Addendum # 2

Bid Opportunity: 25-7630-RFT - Laurentian Public School HVAC and Building Controls Upgrade

E101

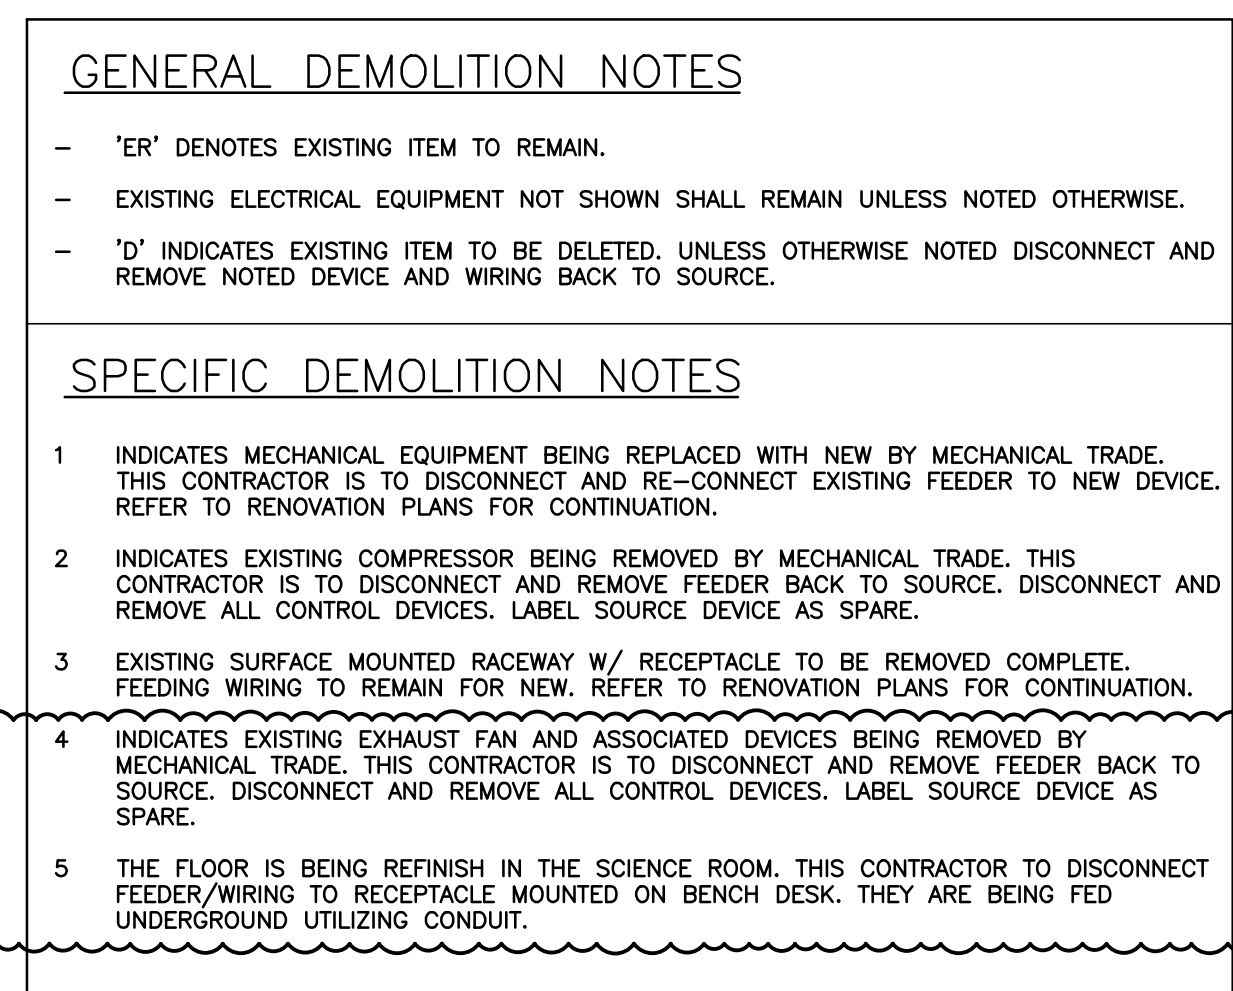
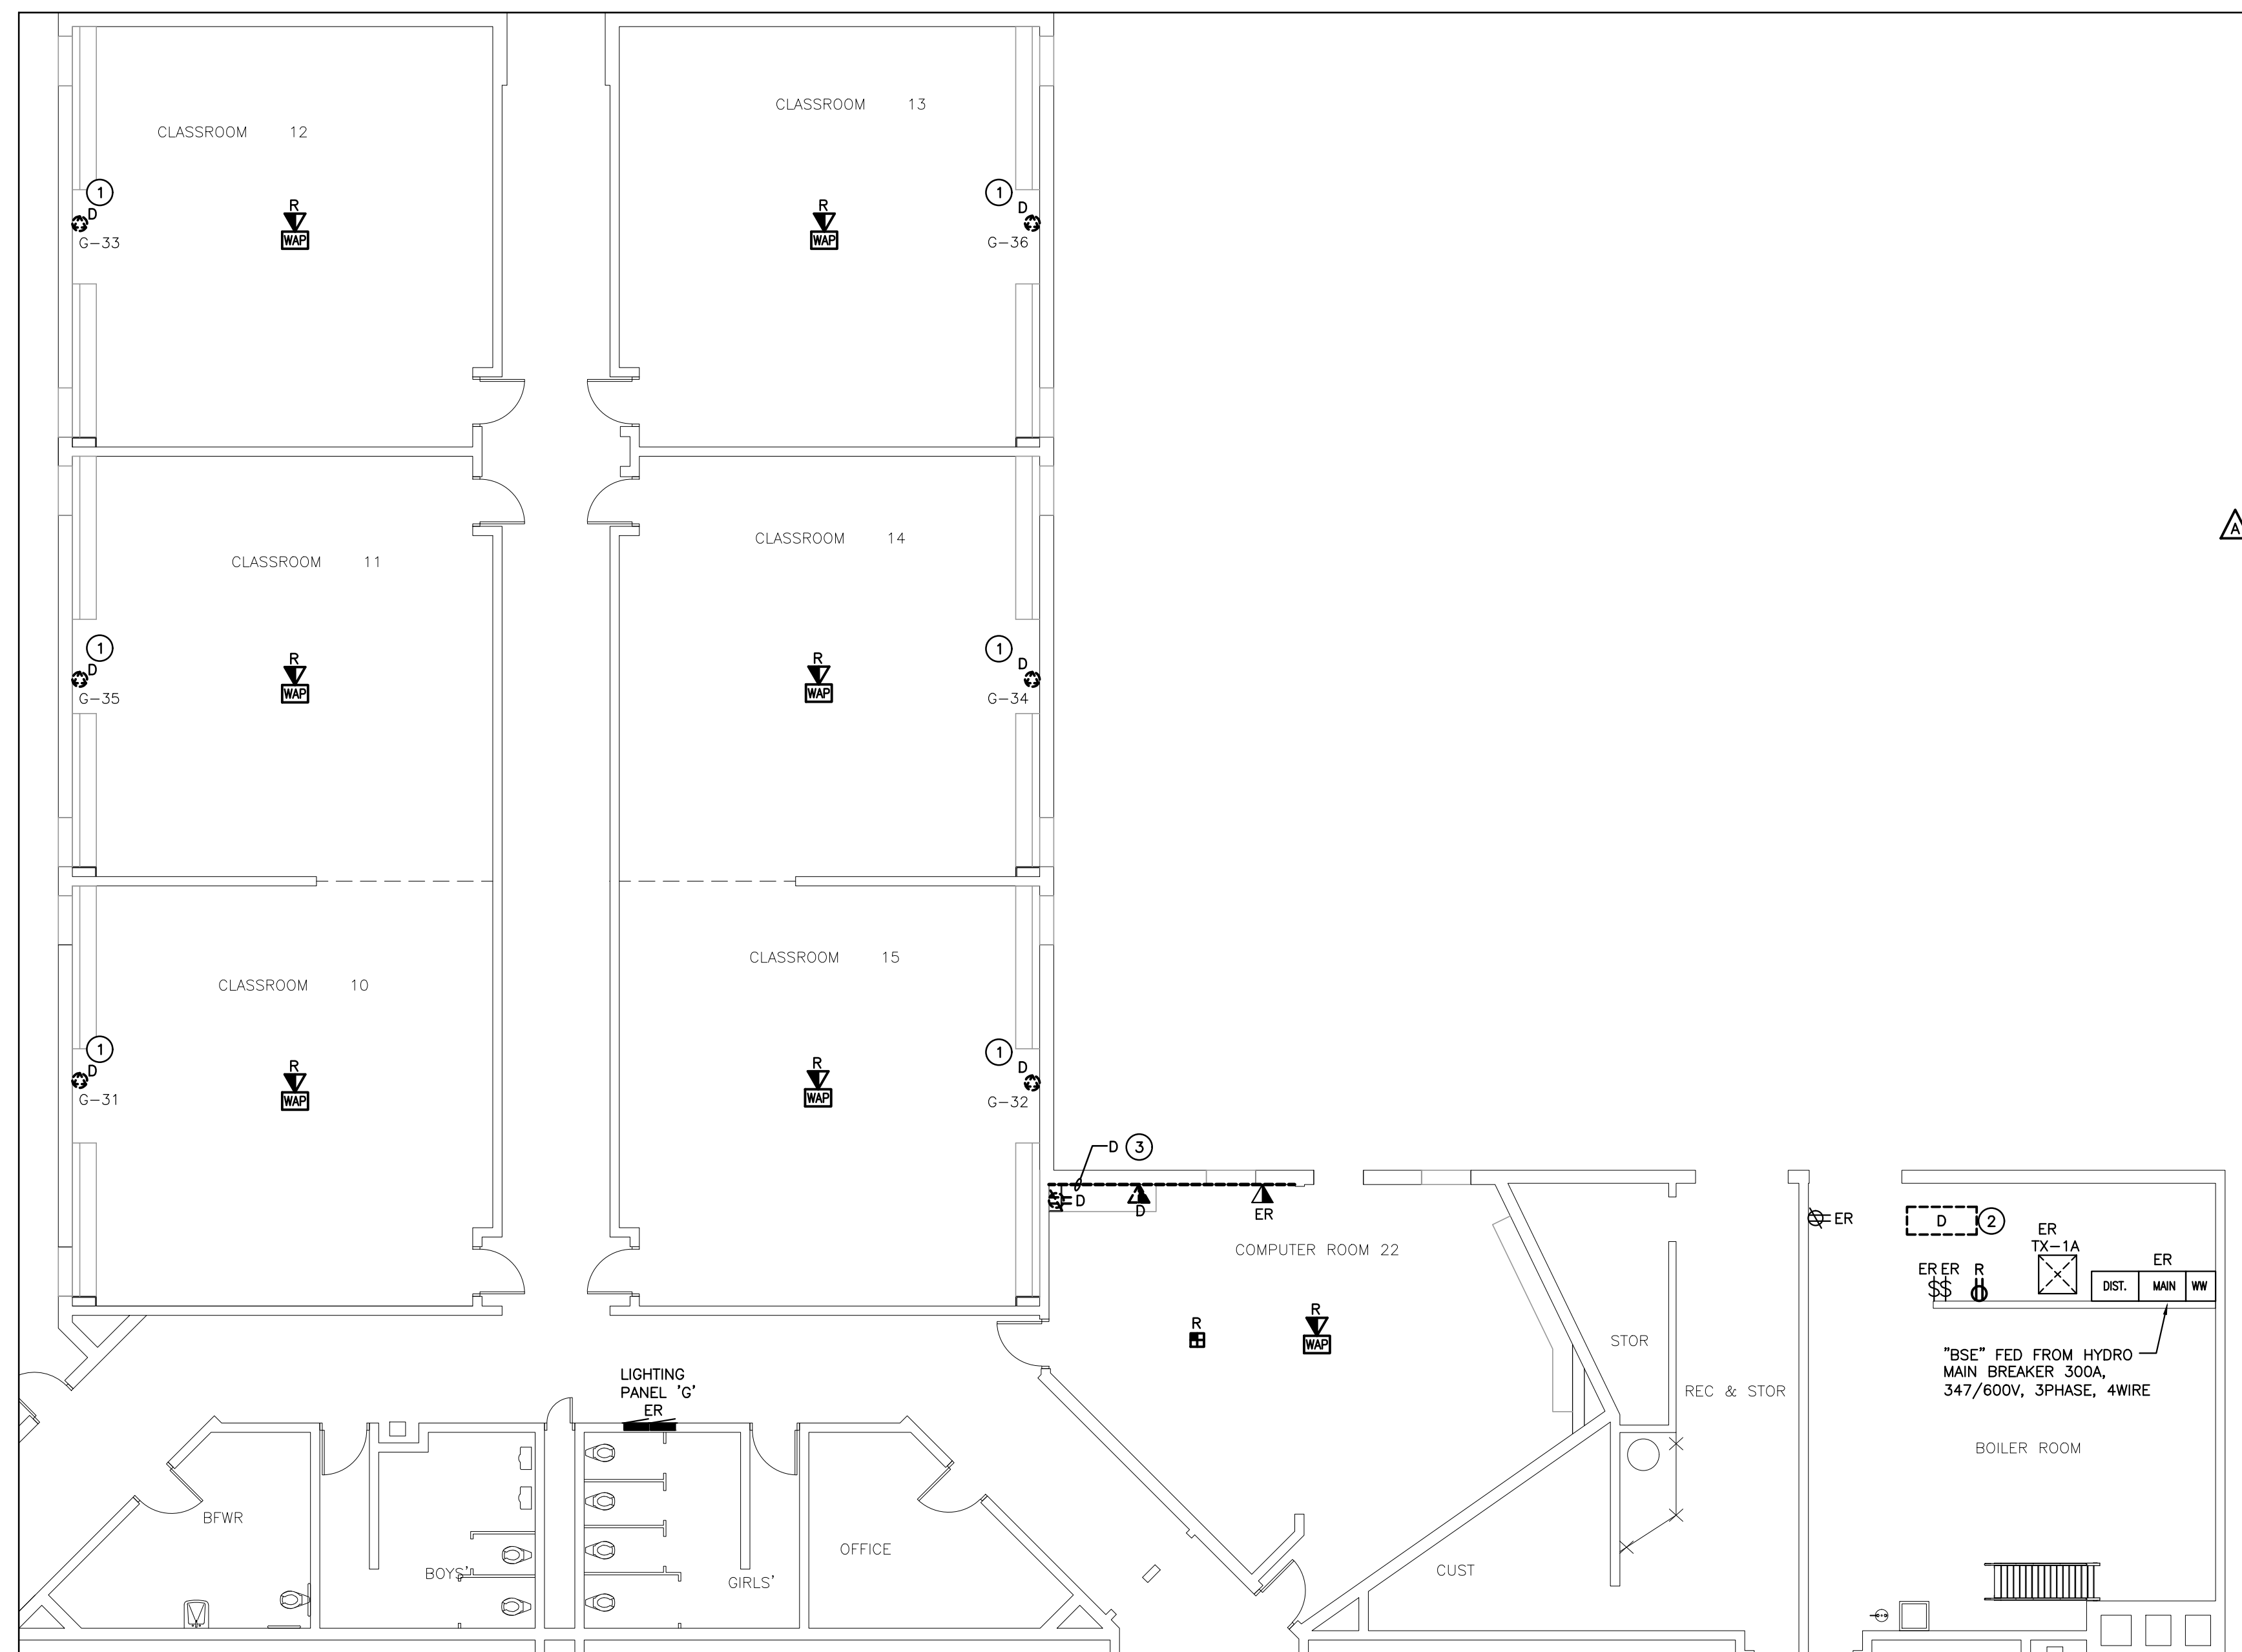
- 2.0 Reference Attached Reissued Drawing E101
 - .1 Add 'Fan Room' to scope of work on key plan as shown.

SCALE :	AS NOTED	SHEET NO : E301
DATE :	09/18/18	
PROJECT NO :	2024-0789-10	
DRAWN BY :	SB	
CHECKED BY :	RV

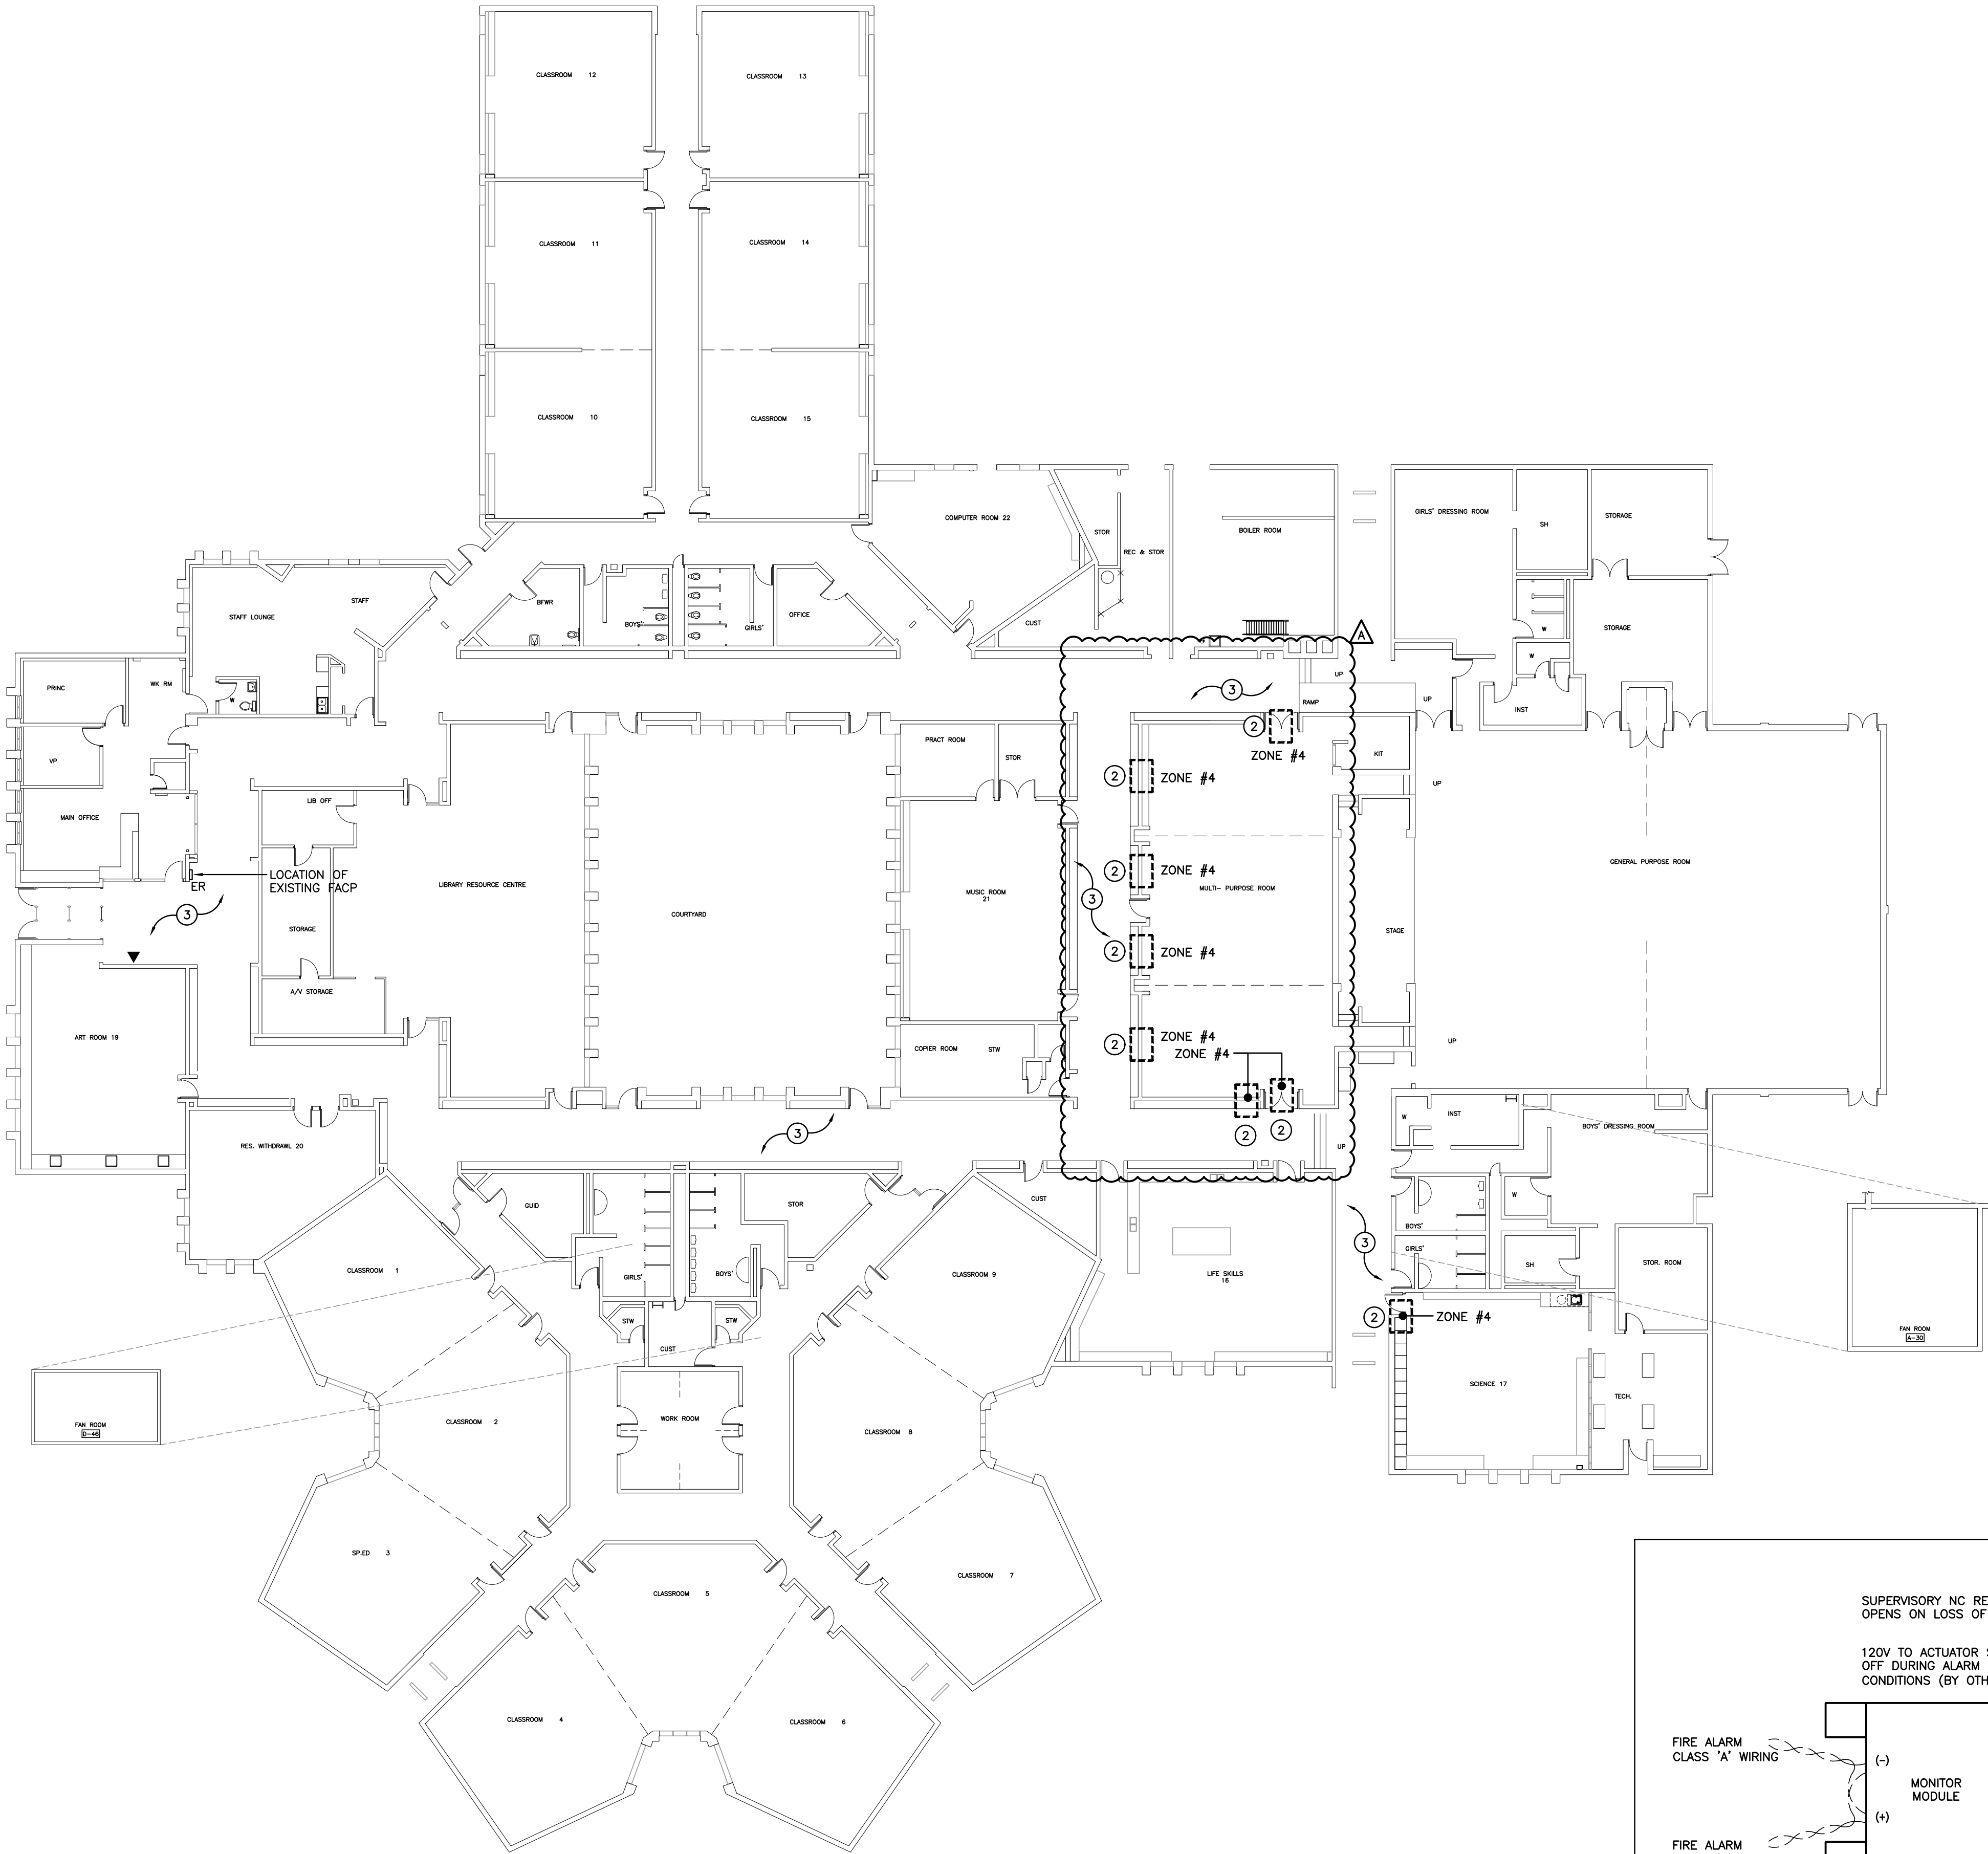
- 4.0 Reference Attached Reissued Drawing E301
 - .1 Add 'D-FAN ROOM DEMOLITION PLAN' to drawing. Remove exhaust fans 'EX-F-2' and 'EX-F-4' completely as shown. Note 4 added to suit.
 - .2 Add new Note 5 regarding the science room.
